From: Nelson, Dan
Sent: Thursday, January 02, 2020 3:39 PM
To: 'Marci Pape'
Subject: RE: Permit 63-34595 - Beneficial Use Field Exam package

SUBJECT: Licensing Review of Water Right 63-34595

Subject: Beneficial Use Field Report - Permit No. 63-34595 (Wilson Properties LP)

STATE OF IDAHO
DEPARTMENT OF WATER RESOURCES
BENEFICIAL USE FIELD REPORT

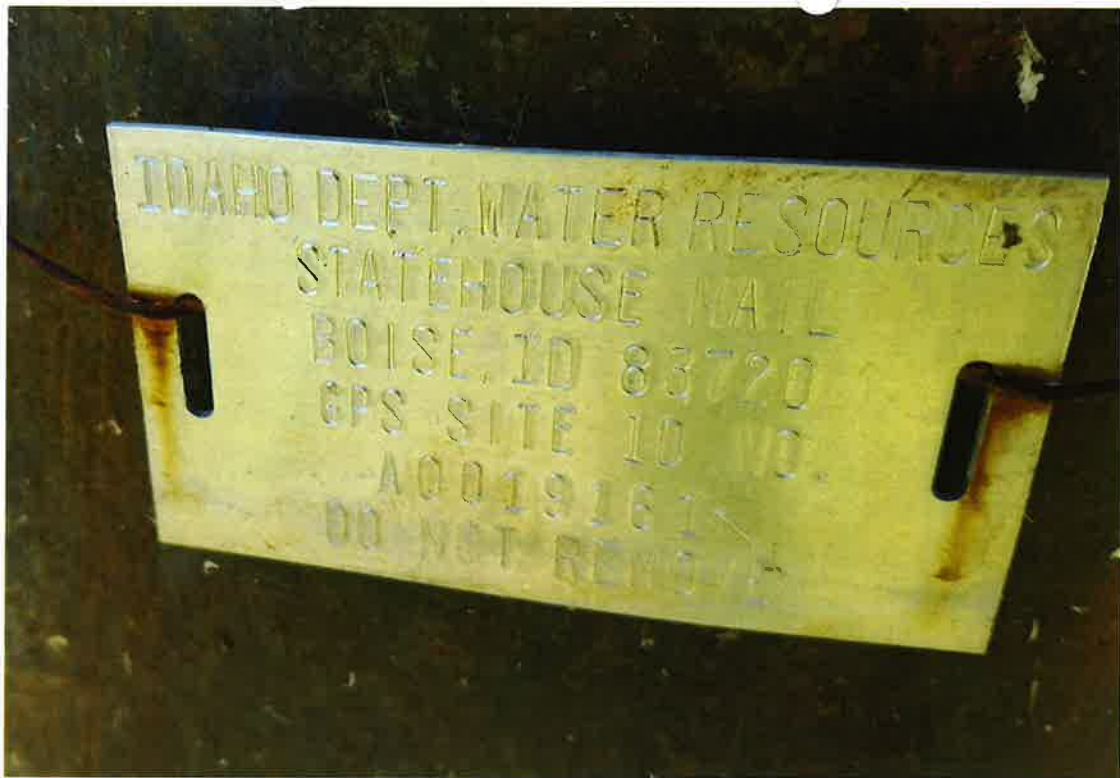
In the pond spreadsheet, we use the soils in the area at the maximum depth of the ponds. You claimed the ponds have an average depth of 8 feet or 96 inches. Without a maximum depth it is hard to determine maximum depth with the average depth, but if we use the Freeform Polygon method (also known as the 2/5 method or 0.4 method), I would assume the maximum depth is 20 feet ($8\text{ft}/0.4=20\text{ft}$) or 240 inches.

The application uses the OL soil with a seepage rate of 0.02 ft/day, but according to the soils information available to the Department, there are no OL soils in these formations. According to the narrative in the application for permit, the ponds drop about $\frac{1}{2}$ way during the winter months. Some of this is from evaporation (approximately 0.2 af worth of evaporation or .02 feet in pond drop) and the rest would be seepage. The narrative suggests that the ponds drop approximately 3.98 feet during the non-irrigation season or 105 days ($\{3/1 \text{ to } 11/15 = 260 \text{ days}\}$ $365 \text{ days} - 260 \text{ days} = 105 \text{ days of non-irrigation}$). This would suggest approximately 0.38 feet of seepage per day ($0.38 \text{ feet drop in pond level} / 105 \text{ days} = 0.0379 \text{ feet per day}$). Here are the seepage volumes for all of the soil types mentioned above:

Seepage on application and field exam using OL soils = 0.02 ft/day = 35.8 acre-feet

Seepage over winter = 0.0379 ft/day = 67.8 acre-feet

Seepage of SW, SM, GP, GC, GW, and GM = 0.2 ft/day = 979.7 acre-feet

Seepage of SC = 0.007 ft/day = 12.5 acre-feet

As you can see from above, all of the seepage rates that I could calculate were much higher than the seepage rates that you recommended.

When I reviewed the ETIdahoStations_poly, I found that ponds were in an area we generally use the Kuna Station (Kuna NWS—USC00105038). The Kuna Station gives a total evaporation loss of 14.9 acre-feet for these ponds. The ponds are also very close to the Boise Airport Station (Boise WSFO Airport NWS—USC00101022). The Airport Station gives a total evaporation loss of 13.5 acre-feet. The application and field exam calculated an evaporation amount from the Caldwell Station of 11.2 af. The Caldwell Station is a

significant distance from these ponds. The seepage amounts from the Kuna and Airport Stations are higher than the amount used in the application for permit and field report.
